#### **HISTORIC LANDMARK BOARD PRELIMINARY REVIEW**

## BRIDGEWAY PARKLET 621-633 BRIDGEWAY

Bridgeway Parklet (CDD 13-117)

PROPOSED SITE PLAN 1/16" = 1'-0"

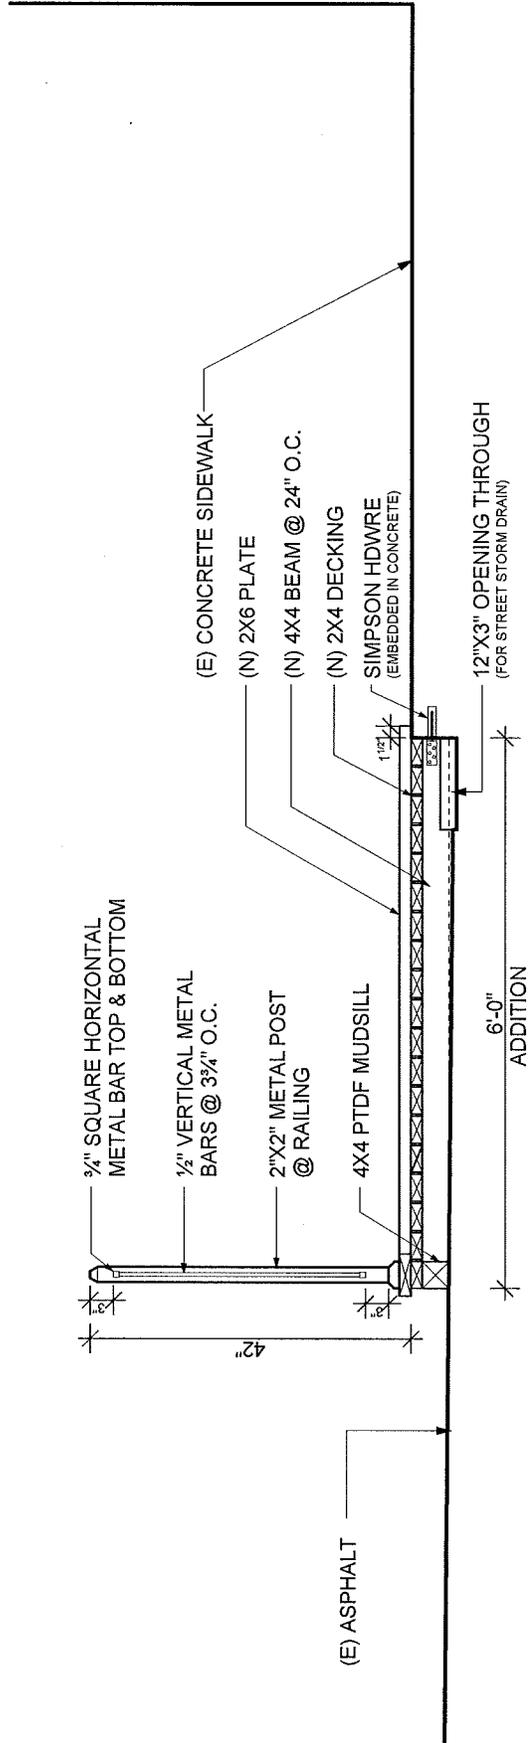
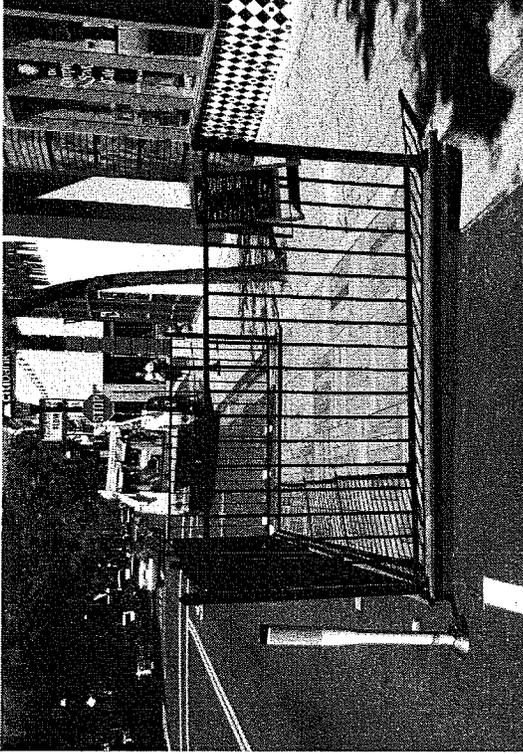
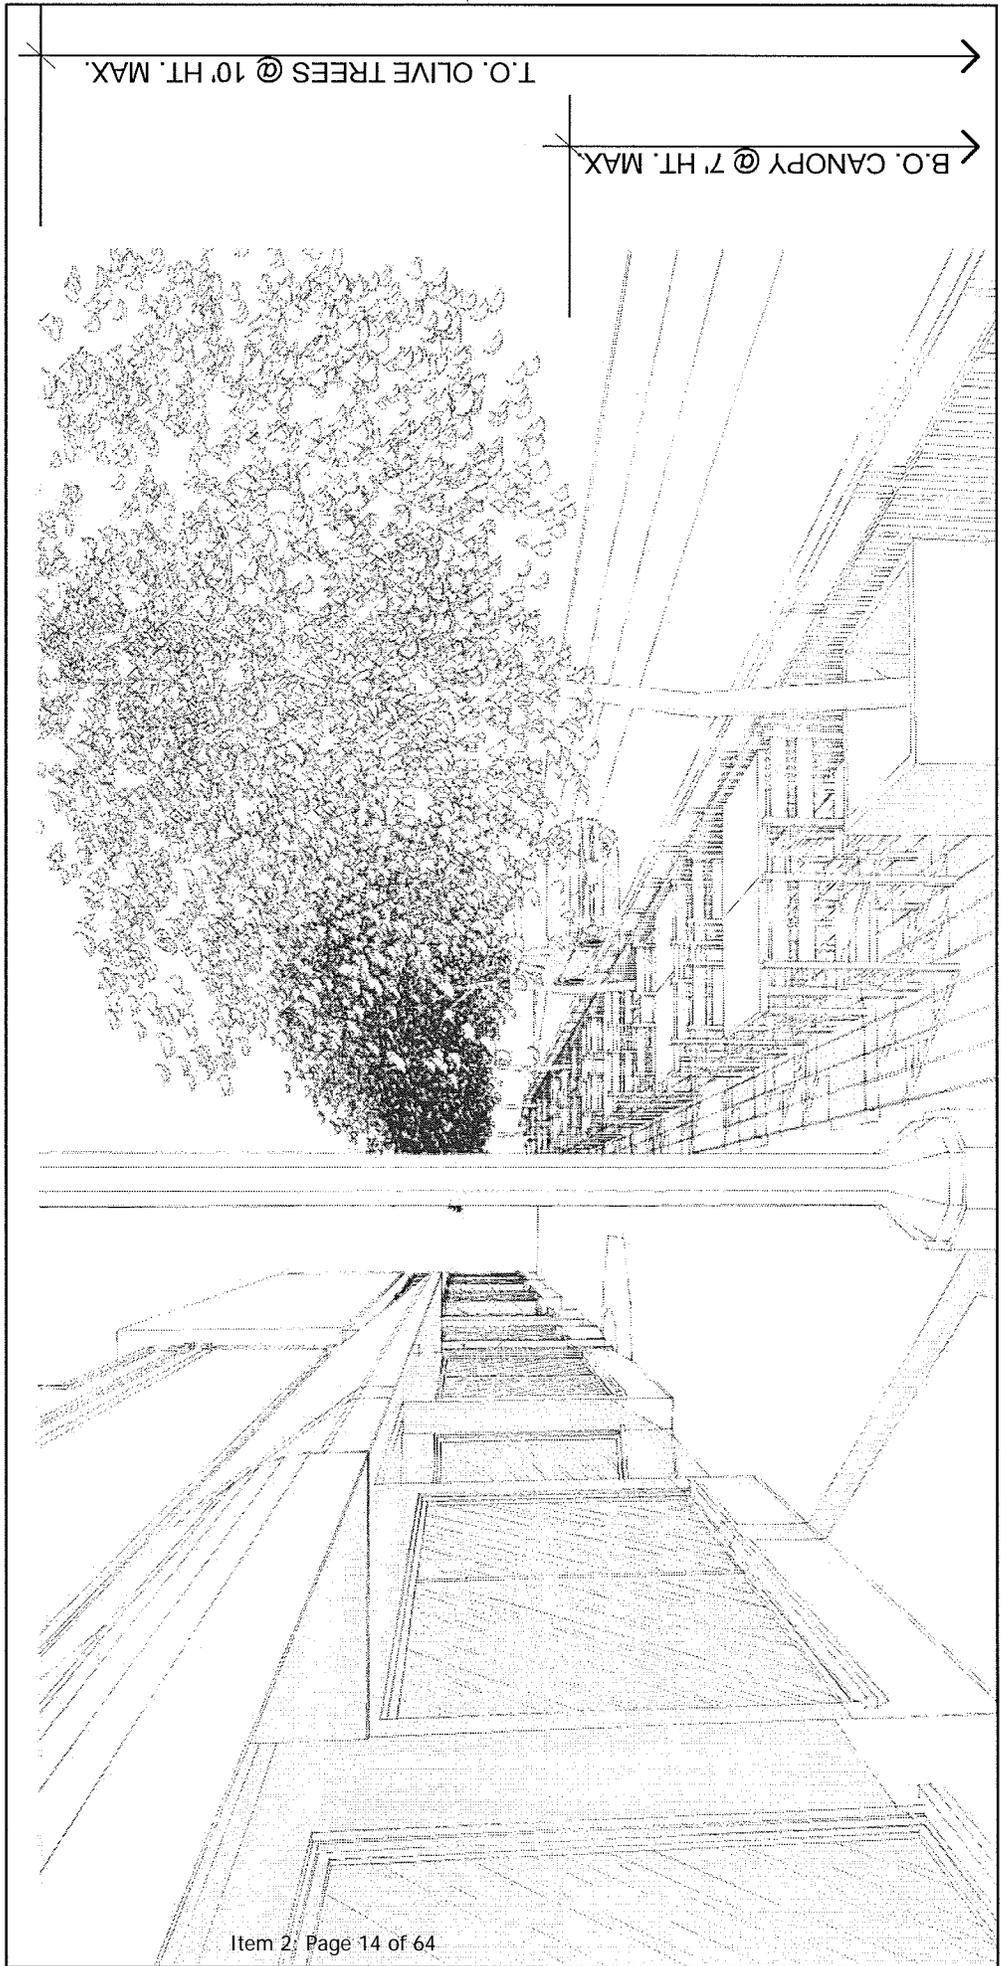
On February 12, 2014, the HLB conducted a preliminary review of the parklet proposal. Following public comment, the HLB discussed the merits of the project including compatibility with the fabric of the Downtown Historic Overlay District and the overall design. In summary, the HLB was supportive of the project and the proposed use. However, the HLB suggested that landscape planters be installed along the street side edge instead of the simple railing and that the planters should be located in a manner so as to restrict pedestrians from entering the street from the parklet.

The general design of the parklet meets the requirements of the Engineering Division regarding access by disabled individuals and easy-to-remove components that are not permanently affixed to the street. The floor plates can be removed to provide access to the gutter for cleaning purposes and the raised platform with a 4x4 mudsill affords protection that is similar to a six-inch concrete curb along sidewalks. The Engineering Division has provided conditions of approval that require the parklet to meet minimum safety, access, and funding requirements. The adjacent businesses will be responsible for maintaining the parklet and will perform all maintenance on the street drainage. Any trees in planters will be required to maintain a canopy that does not impede the vision of any drivers on Bridgeway or those exiting the driveway directly to the south of the parklet. In addition, the canopy shall allow bicyclists a clear view of any vehicles turning onto the roadway or of pedestrians crossing the street.

As noted above, the HLB expressed a preference for planters instead of railing to soften the look of the parklet. Staff visited several parklets in San Francisco and noticed that a common design is to incorporate tall planter boxes with wire cables connecting the planter boxes to prevent pedestrians from crossing through the parklet (see **Exhibit H**). Staff concurs with this design change and recommends that planters be used instead of a railing and to require plantings that do not impede views for safety. Staff also recommends that the applicant provide samples of street furniture for review and approval by the Community Development Director prior to installation of the parklet. The Planning Commission and HLB may also want to consider whether or not to require that the tables and chairs be stored in the businesses overnight.

2. The street side edge of the parklet shall be a continuous planter or of a design that utilizes planters with some other barriers (such as cables) between planters instead of a railing. The design shall not allow for the passage of pedestrians onto the street from the parklet.

**LOCATION OF PUBLIC TABLES IN PARKLET**

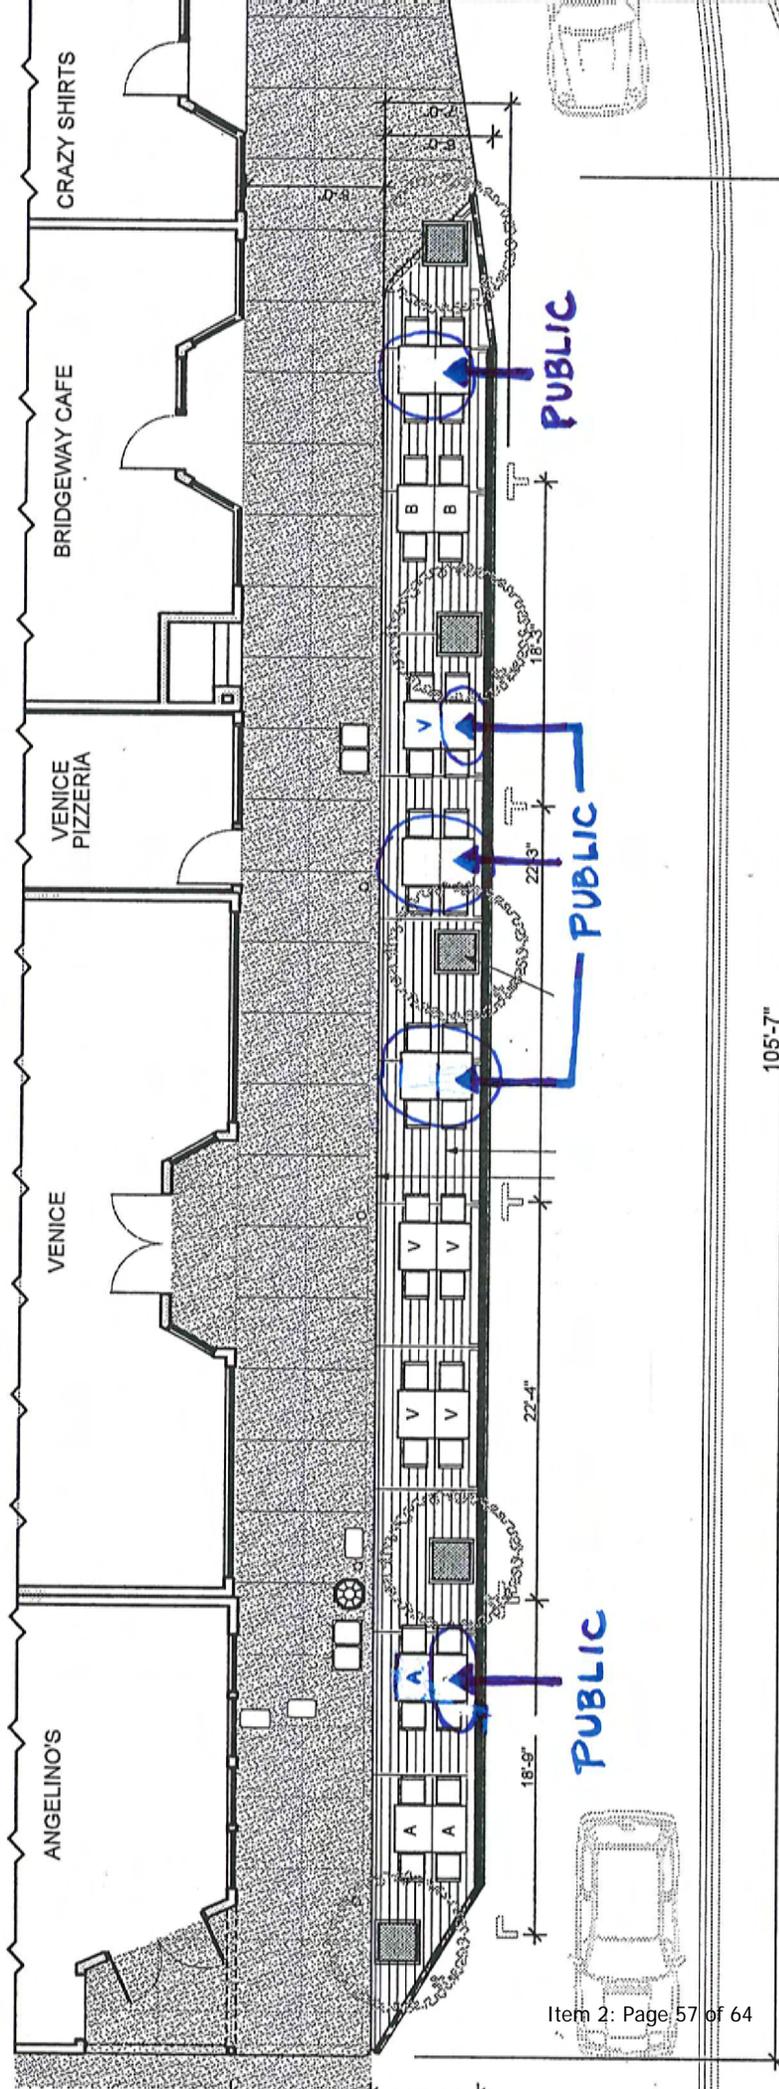
Based on the approach stated above, the parklet would have 10 tables dedicated to the adjacent businesses and 8 tables would be available to the general public. Staff has reviewed the layout and is recommending that each business be permitted to have their dedicated tables in close proximity to their main entrances. This would spread out the public tables throughout the parklet with one table located in front of Angelino Restaurant, five between Venice Gourmet and Venice Pizza, and four in front of the Bridgeway Café. Staff has prepared a site plan of the possible location for the public tables based on this scenario (see **Exhibit I**). Staff has also developed draft conditions of approval that will be part of the Community Development Director's approval of the project which include signage stipulating which tables are for the public at large (see **Exhibit J**).

1. A total of eight tables shall be dedicated for the public at large throughout the parklet. Permanent signage shall be affixed to the planter boxes adjacent to the dedicated public tables. The extra table in front of Angelino and the Venice Pizza restaurants shall also be signed to indicate that they are for the public at large.
